RE: Case SP 2020-08 | Site Plan for Raising Cane's – 5036 Rufe Snow Drive

The City of North Richland Hills Development Review Committee (DRC) has reviewed the case listed above and has certified that it meets the requirements for site plan approval. You may proceed with building permit applications at your convenience, but the application must be submitted within one year of DRC certification of the site plan.

This approval certifies that the developer and all associated parties agree to follow the plans that were certified by the DRC on March 1, 2021. The applicable plan sheets are attached and are subject to the following conditions:

**SITE KEYNOTE
PLAN**

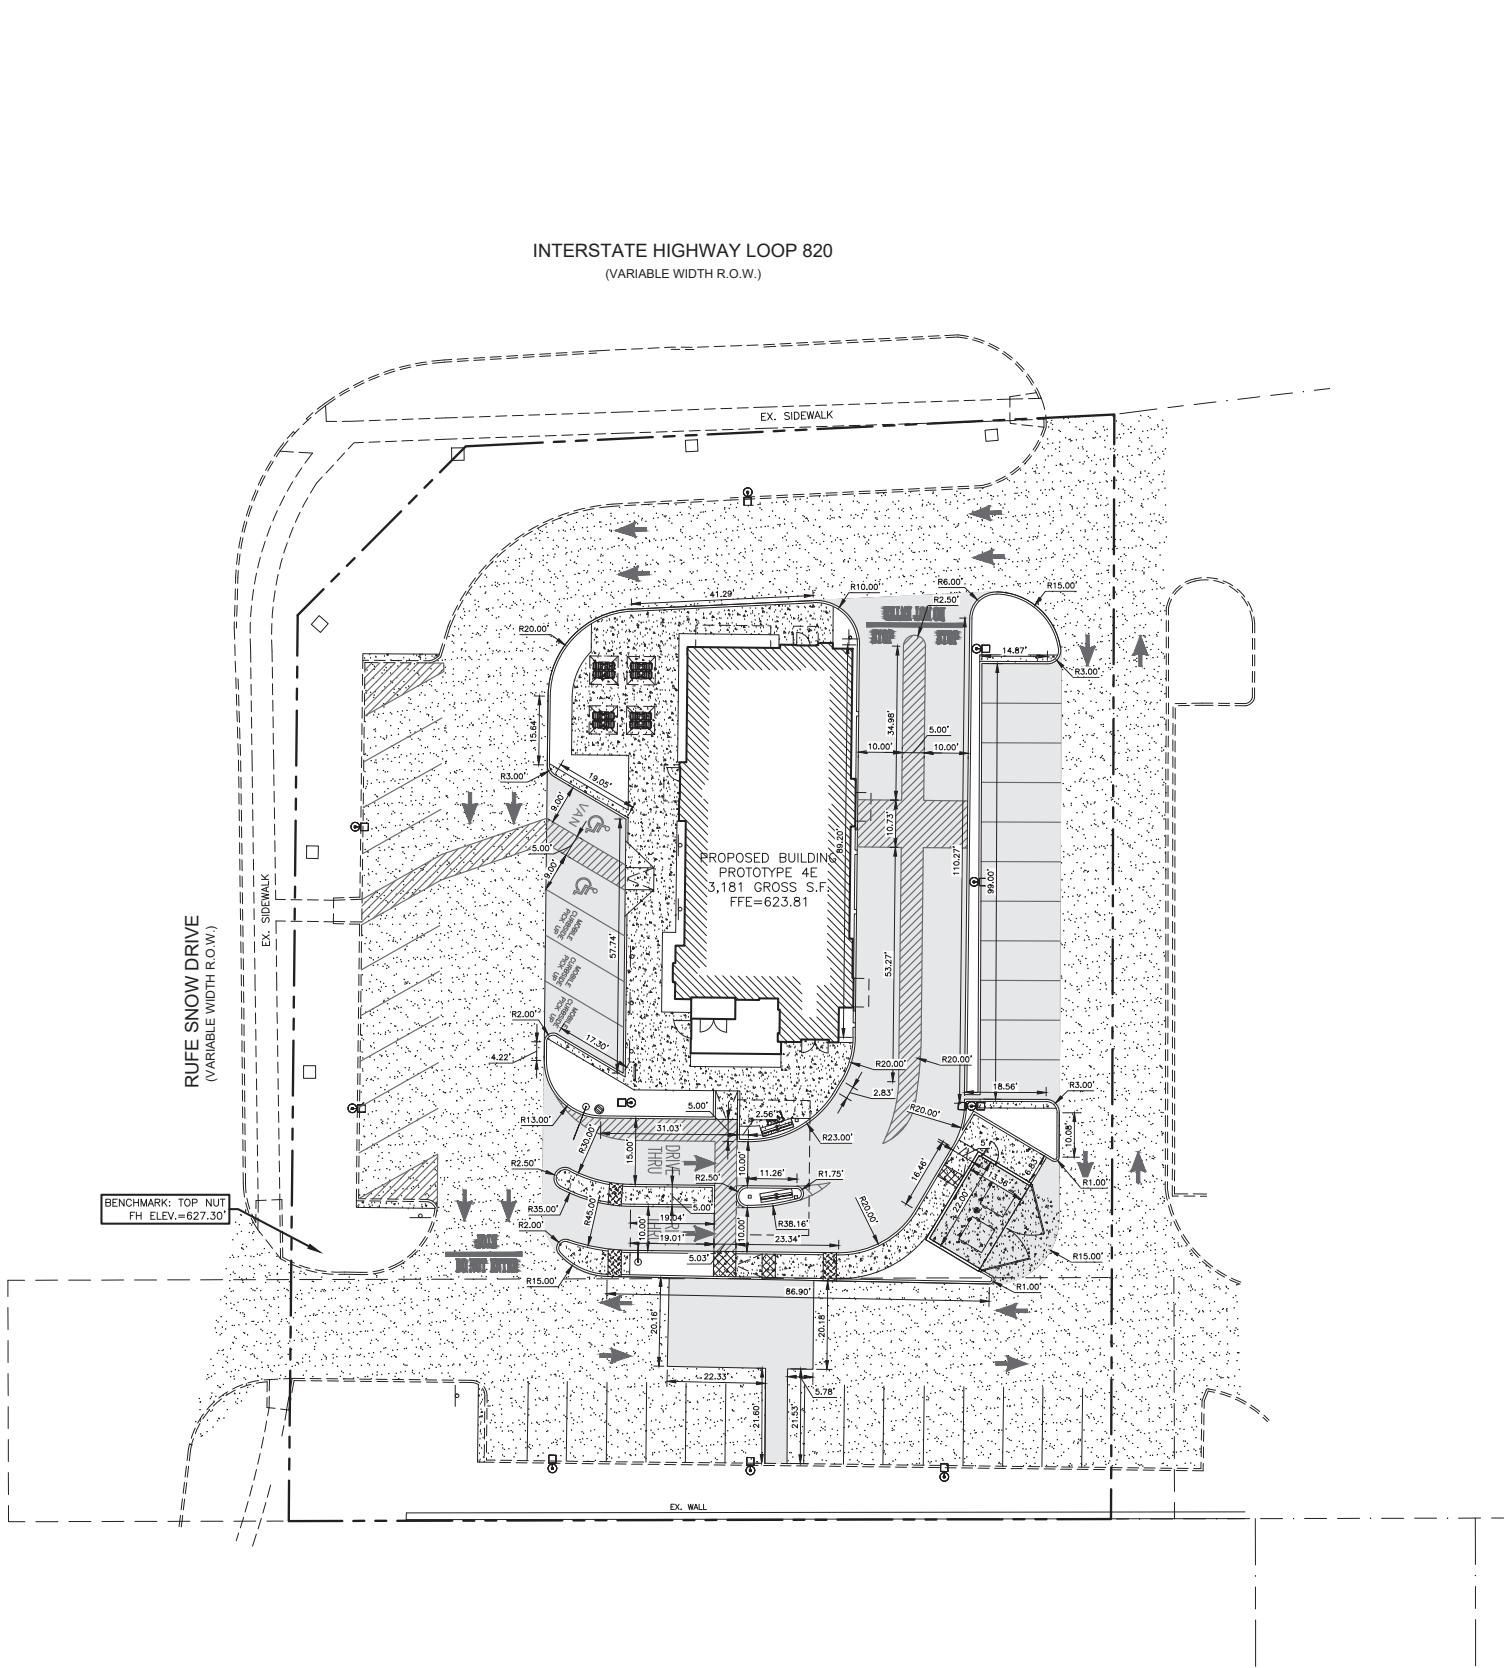
1. The landscape plan will be used for determining the location, species, and quantities of plant material to be used on the site, as the site layout does not reflect the final approved version. Refer to the site keynote plan for approved site layout.
2. Wall signs shown on the building elevations are for reference only. Signs for the building and site will be reviewed separately through the sign permit process.
